TECHNICAL SERVICE BULLETIN

77-A-12

CYLINDER HEAD BOLTS AND GASKET

TR7

FIGURE I

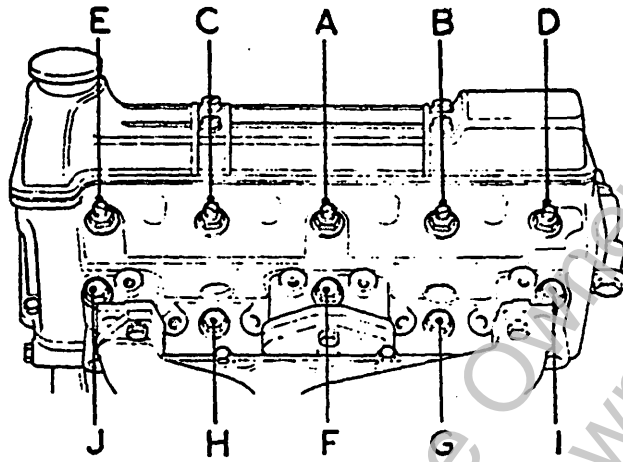
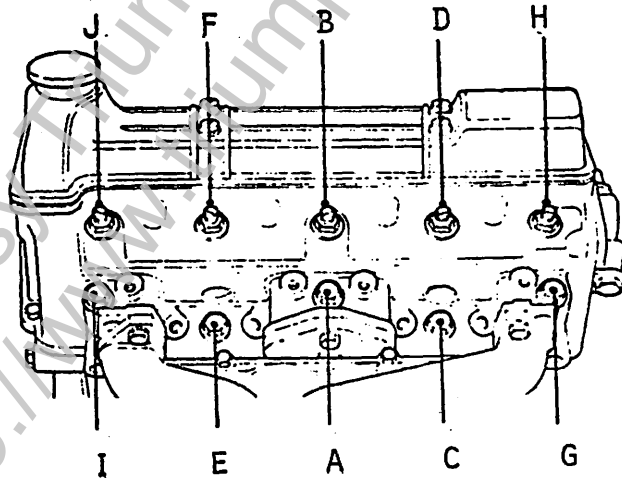
IMPORTANT: To avoid distortion of the cylinder head, the tightening sequence has been amended and must be followed (see diagram). When releasing the nuts and bolts, prior to removing the cylinder head, the above sequence must be reversed. When checking the torque loading of the nuts and bolts, they should first be slackened off to overcome static friction and then retightened to the correct torque figure, which has now been changed to 45 to 50 lbs/ft. On early 1977 TR7s prior to engine number CV10330, the sequence, as depicted in the workshop manual, should be followed and note, the cylinder head torque is 45 to 55 lbs/ft.

For cars prior to engine number CV10330 refer to Figure I.
For cars subsequent to engine number CV10330 refer to Figure II.

TORQUE 45-55 lbs/ft.

TORQUE 45-50 lbs/ft.
